Merged Document Report

Application No.: PL8163

Description :	
Address :	11910 LEOPARD CORPUS CHRISTI TX 78410
Record Type :

FINAL PLAT OF ALARCON ADDITION BLOCK 1, LOTS 1 AND 2

SITE MAP
NOT TO SCALE

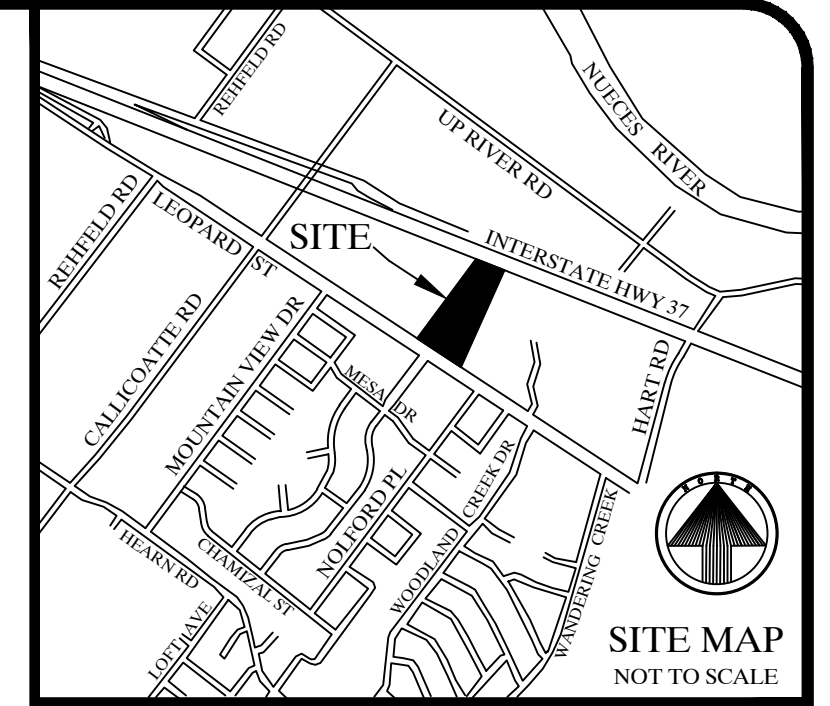
Comment ID	Page Reference	Annotation Type	Author : Department	Status	Review Comments	Applicant Response Comments
20	plat	Note	Andrea Fernandez : DS	Open	GIS Comments: 1: Plat - The plat closes within acceptable engineering standards. 2: Plat - LOFT AVE on site map should be LOTT AVE	
22	plat	Note	Andrea Fernandez : DS	Open	Parks: No comments	
1	plat	Note	Andrea Fernandez : DS	Open	Planning comment: Missing acreage in plat description	
11	plat	Note	Andrea Fernandez : DS	Open	Planning Comment: Denote block number	
19	utility	Note	Melanie Barrera : DS	Open	note: each lot to have individual service connections, per UDC 8.2	
26	utility	Note	Melanie Barrera : DS	Open	display all proposed utilities, including fire hydrants, to demonstrate the platted property will comply with UDC 3.8.5.D.4.	
27	utility	Note	Andrea Fernandez : DS	Open	Planning comment: If planning to submit WW waiver please see this site for form: https://www.cctexas.com/sites/default/files/4012%20t%20Waiver%20Application%20Form.pdf

FINAL PLAT OF ALARCON ADDITION BLOCK 1, LOTS 1 AND 2

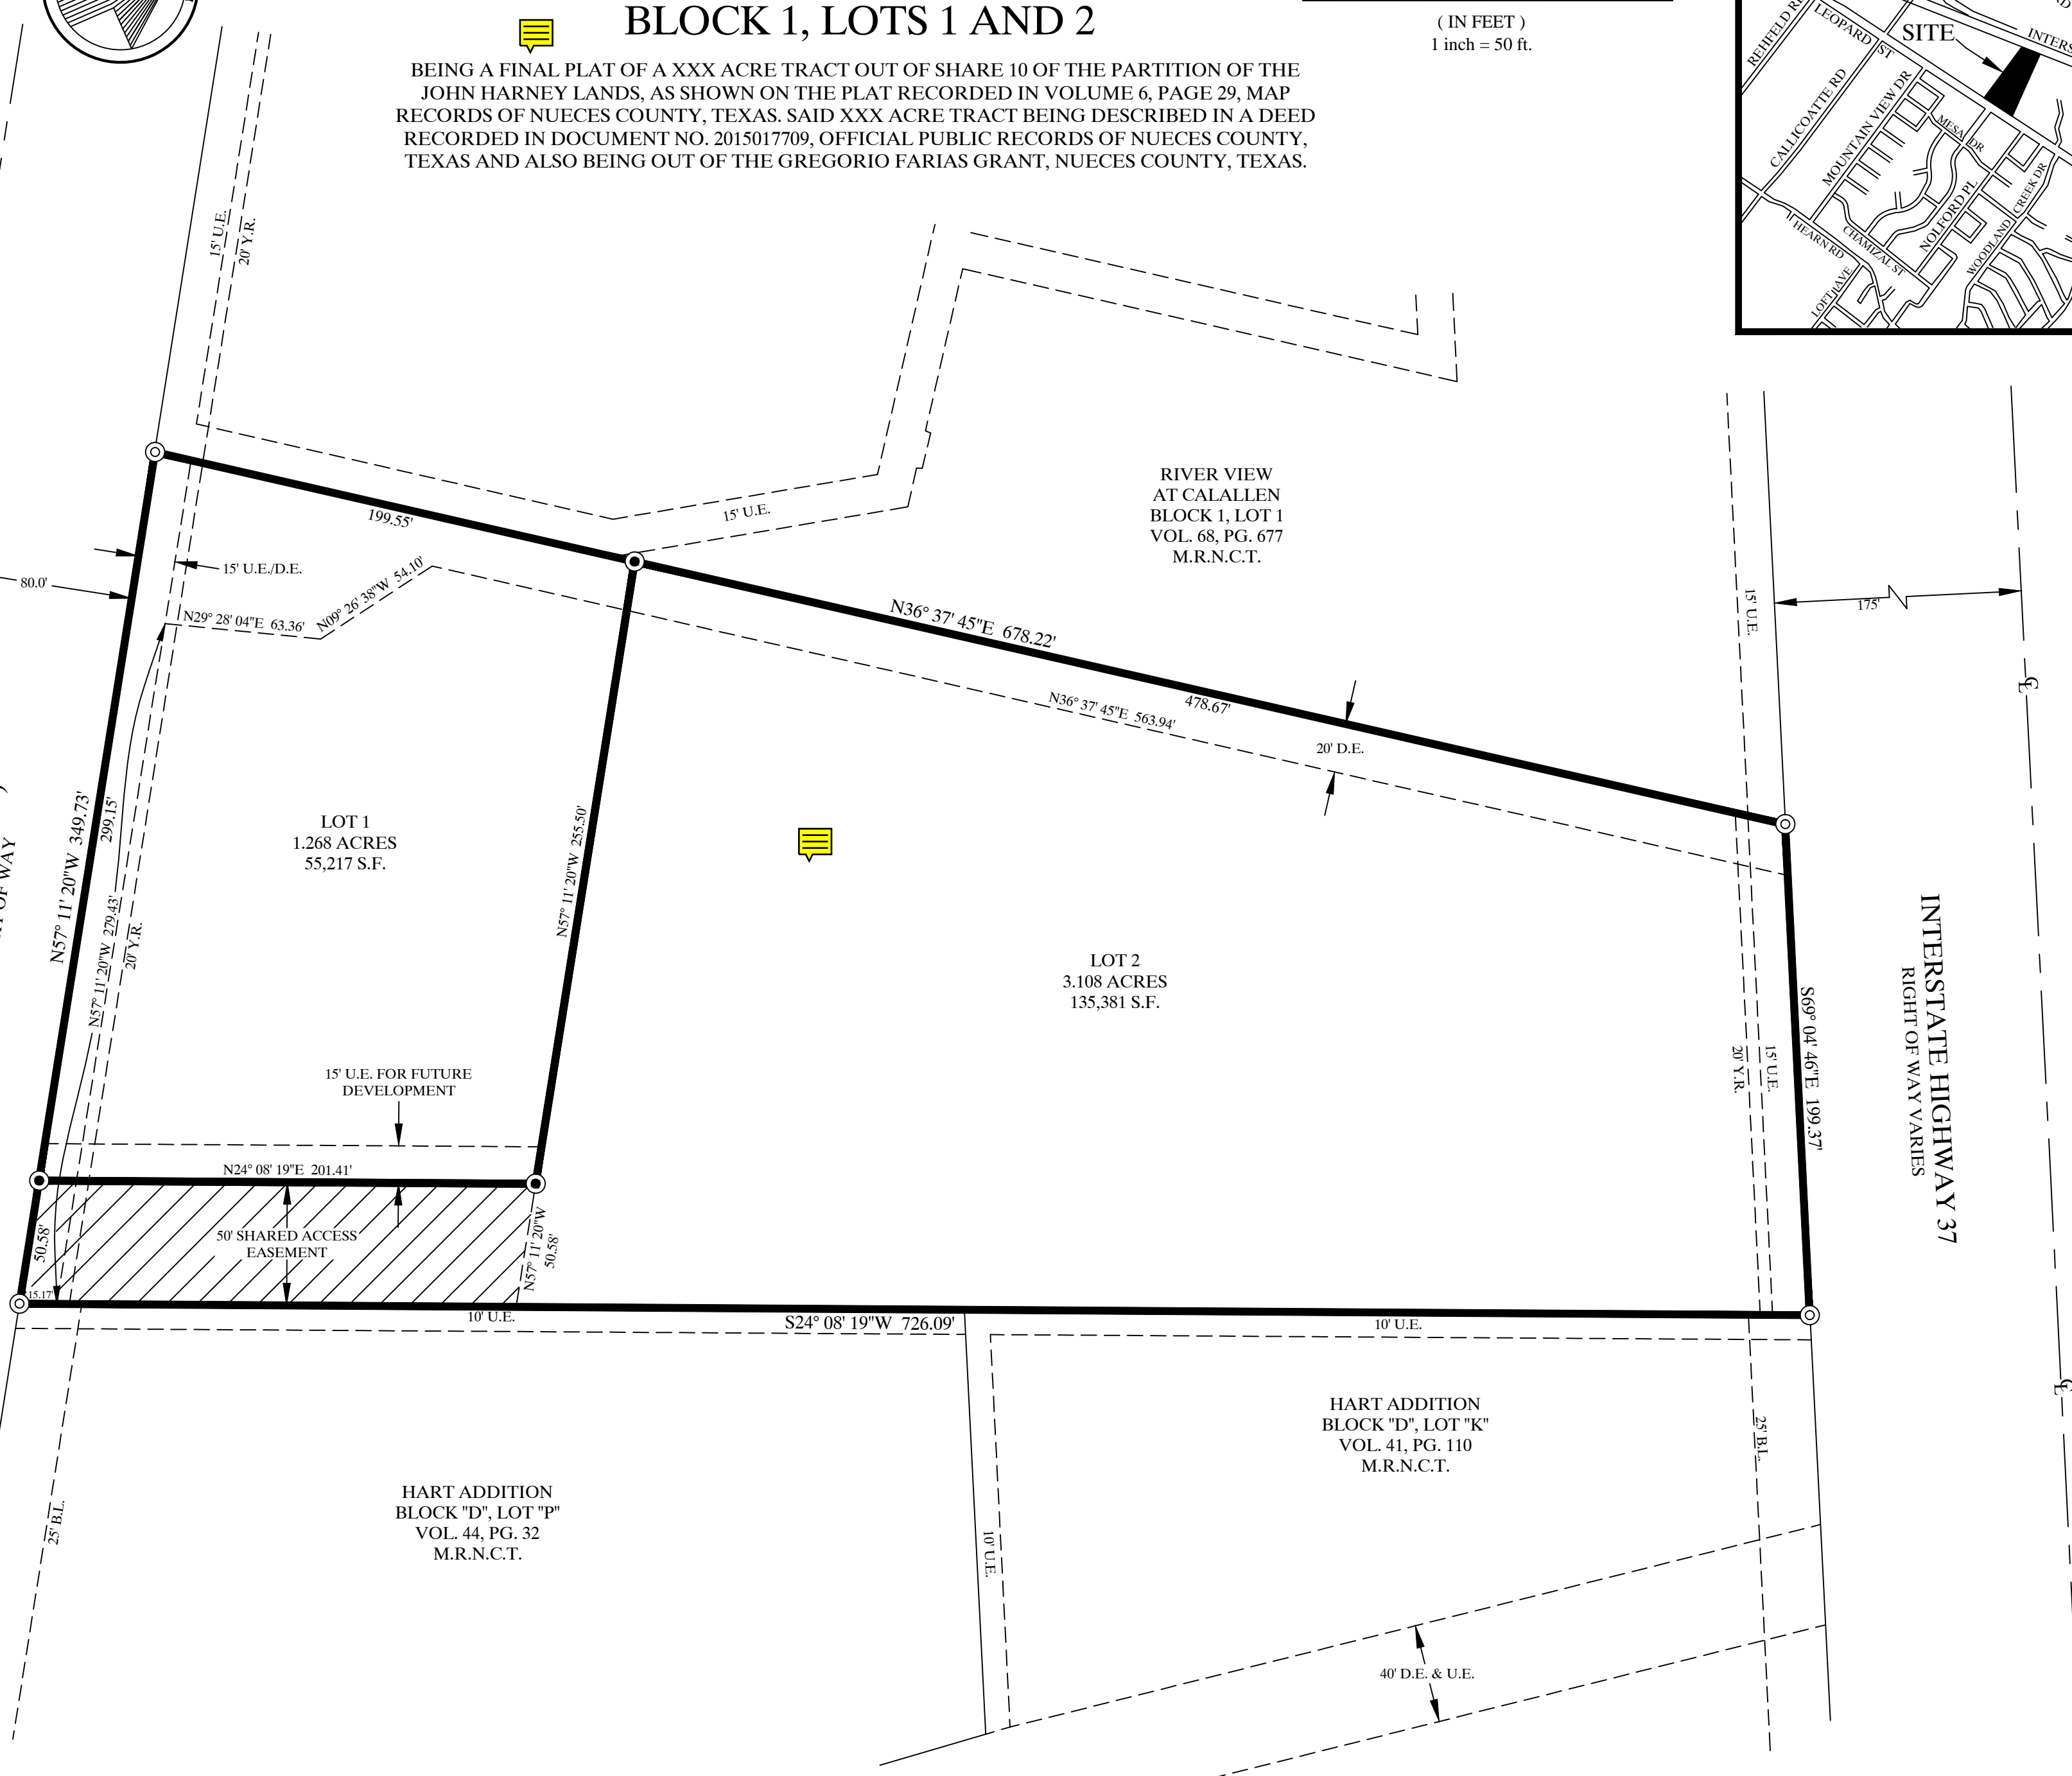
Comment ID	Page Reference	Annotation Type	Author : Department	Status	Review Comments	Applicant Response Comments
2	plat	Note	Andrea Fernandez : DS	Open	<p>TxDot Comments: Regarding access/drainage onto the state roadway system.</p> <p><input type="checkbox"/>No increase in storm water discharge to State right-of-way shall be accepted by TxDOT. <input type="checkbox"/>TxDOT Permits will be issued in accordance with the access management standards and all applicable state and federal laws, including rules and regulations. Access connection spacing, materials, geometrics, accessibility, and other design specifications will be considered, as well as the impact on drainage and hydraulics, utility location or relocation, and the environment that will result from the requested construction of an access connection. 43 Tex. Admin. Code 11.52 (2020). <input type="checkbox"/>Drainage improvements shall accommodate runoff from the upstream drainage area in its anticipated maximum "build-out" or "fully developed" condition, and shall be designed to prevent overloading the capacity of the downstream drainage system <input type="checkbox"/>If the owner responsible for maintenance of the permanent stormwater or water quality control fails to maintain the control to TXDOT ROW, the owner shall correct the problem</p>

Comment ID	Page Reference	Annotation Type	Author : Department	Status	Review Comments	Applicant Response Comments
3	plat	Note	Andrea Fernandez : DS	Open	CCRTA Comments: This plat is located along and immediately adjacent to out bound bus stop 1385 served by the CCRTA bus Route 27 Leopard. This stop is located along the north right-of-way line of Leopard Street and is approximately 100 feet east of the Western Drive intersection with Leopard St. At this location the bus stop is in alignment with an existing mid-block Leopard St. pedestrian crosswalk. Please note that the concrete in-street stopping pad, concrete ramp and ADA compliant landing pad, Iconic bus bench, trash receptacle and sign/pole assembly are all located completely within the Leopard Street right-of-way. Should any adjustments, relocation or demolition be required for this existing bus stop, a future meeting with CCRTA staff to discuss necessary or desired alterations will be warranted.

4	plat	Note	Andrea Fernandez : DS	Open	Floodplain: No comments	
5	plat	Note	Andrea Fernandez : DS	Open	AEP Transmission: No comments	
6	plat	Note	Andrea Fernandez : DS	Open	AEP Distribution: No comments	
7	plat	Note	Andrea Fernandez : DS	Open	NASCC: No comments	
9	plat	Note	Andrea Fernandez : DS	Open	Planning comment: Confirm correct acreage as deed/NCAD acreage do not match acreage given on plat.	
10	plat	Note	Andrea Fernandez : DS	Open	Planning comment: In vicinity map "Loft Ave" should be Lott Ave (see GIS comment 2)	
13	plat	Note	Andrea Fernandez : DS	Open	Traffic Comments: 1: Plat - Existing bus stop and pedestrian crossing may require reconstruction to avoid conflicting with access easement 2: Plat - Existing drainage channel may conflict with proposed or future development 3: Plat - Recommend access easement also be extended parallel to Leopard St in front on Lot 1 4: Infor: - All new streetlight systems in residential subdivisions shall utilize concrete poles per IDM Chapter 8 section 1.2.B.a 5; Infor: - Proposed driveway access to a public City Street shall conform to access management standards outlined in Article 7 of the UDC (UDC 7.1.7)

Comment ID	Page Reference	Annotation Type	Author : Department	Status	Review Comments	Applicant Response Comments
					<p>6: Infor: - Per Master Transportation Plan, Leopard St is classified as an A-2 Arterial Street. Driveways shall conform to minimum driveway spacing standards outlined in the UDC 7.1.7A</p> <p>7: Infor: - Per City of Corpus Christi Code of Ordinances Section 49-2 A ROW Construction Permit, issued by Traffic Engineering, will also be required to perform work within or occupy public right-of-way separate of plat approval and infrastructure improvements.</p> <p>8: Infor: - For further information or to acquire a ROW Construction Permit please email ROWManagement@cctexas.com</p> <p>9: Infor: - Working without an approved ROW Construction Permit will be considered non-compliance and can be subject to fines and / or citations.</p> <p>10: Infor: - Work to tie in driveways to City Right-of-Way will require a Right-of-Way permit from Traffic Engineering.</p>

14	plat	Note	Andrea Fernandez : DS	Open	<p>Fire comments 1-10:</p> <p>1: Infor. - Fire review will be based on use as zoned CG2. Review will not encompass the use of the property as residential apartments or townhomes. Such use will need further review.</p> <p>2: Plat - Note: All code reference is based on currently adopted International Fire Code (IFC) 2021 and Corpus Christi Water Distribution Standards.</p> <p>3: Plat -"Commercial Development shall have a fire flow of 1,500 GPM with 20 psi residual Fire hydrant every 300 feet and operational."</p> <p>4: Plat - 507.5.1 (amendment) Where Required: All premises, other than one-family detached dwellings, where buildings or portions of buildings are located more than 150 feet from a fire hydrant shall be provided with approved on-site hydrants and water mains capable of supplying the fire flow require by the fire official. The minimum arrangement being so as to have a hydrant available for distribution of hose to any portion of building on the premises at distances not exceeding 300 feet.</p> <p>5: Plat - 507.5.4 Obstruction. Unobstructed access to fire hydrants shall be maintained at all times. The fire department shall not be deterred or hindered from gaining immediate access to fire protection equipment or fire hydrants. Note: Hose lay from a hydrant will not cross an arterial street. In this instance: the hydrant across the street on</p>

Comment ID	Page Reference	Annotation Type	Author : Department	Status	Review Comments	Applicant Response Comments
					<p>Leopard is not available for fire water supplies.</p> <p>6: Plat - 912.2.3 (amendment) Proximity to Hydrant: Fire department connections (FDC) for each sprinkler system or standpipe system shall be located not more than 100 feet from the nearest fire hydrant connected to an approved water</p> <p>7: Plat - 503.1.1 (amendment) Buildings and facilities: Approved fire apparatus access roads shall be provided for every facility, building, or portion of a building hereafter constructed or moved into or within the jurisdiction. The fire apparatus access road shall allow access to three (3) sides of buildings in excess of fifteen thousand (15,000) square feet and all sides for buildings in excess of thirty thousand (30,000) square feet.</p> <p>8: Plat - 3310.1 Required access. Approved vehicle access for firefighting shall be provided to all construction or demolition sites. Vehicle access shall be provided to within 100 feet of temporary or permanent fire department connections. Vehicle access shall be provided by either temporary or permanent roads, capable of supporting vehicle loading under all weather conditions. Vehicle access shall be maintained until permanent fire apparatus access roads are available.</p> <p>9: Plat - D102.1 Access and loading. Facilities, buildings, or portions of buildings hereafter constructed shall be accessible to fire department apparatus by way of an approved fire apparatus access road with an asphalt, concrete or other approved driving surface capable of supporting the imposed load of fire apparatus weighing at least 75,000 pounds.</p> <p>10: Plat - 503.1.1 (amendment) Buildings and facilities: During construction, when combustibles are brought on to the site in such quantities as deemed hazardous by the fire official, access roads and a suitable temporary supply of water acceptable the fire department shall be provided and maintained.</p>

15	plat	Note	Andrea Fernandez : DS	Open	<p>Fire comments 11-19:</p> <p>11: Plat - 503.2.1 Dimensions. Fire apparatus access roads shall have an unobstructed width of not less than 20 feet, exclusive of shoulders and an unobstructed vertical clearance of not less than 13 feet 6 inches.</p> <p>12: Plat - D103.1 Access road width with a hydrant. Where a fire hydrant is located on a fire apparatus access road, the minimum road width shall be 26 feet, exclusive of shoulders.</p> <p>13: Infor. - "The minimum required width of 20 feet</p>

Comment ID	Page Reference	Annotation Type	Author : Department	Status	Review Comments	Applicant Response Comments
					<p>that shall be maintained means a clear unobstructed path that allows the passage of fire apparatus.</p> <p>1. Where Fire Apparatus Access is constructed to the minimum of 20 feet, no parking is allowed within the fire apparatus lane.</p> <p>2. Where a fire hydrant is located on the street, the minimum unobstructed clearance shall be 26 feet. In this instance, no parking is allowed on one side of the street.</p> <p>3. The minimum UDC residential street width is 28 ft. curb to curb. Any parking along the street that reduces the width to less than 20 ft. is prohibited and the Fire Code Official and will require painting NO PARKING-FIRE LANE along one side of the street."</p> <p>14: Infor. - "Note: Calculated Turning Radii for Fire Apparatus: Inside Turn: 20 ft. 3 in. Curb to curb: 36 ft. 8 in. Wall to wall: 44 ft. 8 in."</p> <p>15: Plat - 503.4 Obstruction of fire apparatus access roads. Fire apparatus access roads shall not be obstructed in any manner, including the parking of vehicles. The minimum widths and clearances established in sections D103 shall always be maintained.</p> <p>16: Plat - 503.3 Marking: Where required by the fire code official, approved signs, or other approved notices the include the words NO PARKING-FIRE LANE shall be provided for fire apparatus access roads to identify such roads to prohibit the obstruction thereof. The designation of a fire lane can be marked with conspicuous signs which have the words: Fire Lane-No Parking at 50-foot intervals. In lieu of signs, fire lanes may be marked along curbing with the wording, Fire Lane-No Parking at 15-foot intervals.</p> <p>17: Plat - Table D103.4 Requirements for Dead-end fire apparatus access roads. Turnaround provisions shall be provided with a 96-foot diameter cul-de-sac.</p> <p>18: Plat - 503.2.5 Dead ends. Dead-end fire apparatus access roads more than 150 feet in length shall be provided with an approved area for turning around fire apparatus.</p> <p>19: Infor. - Commercial development of the property will require further Development Services review.</p>
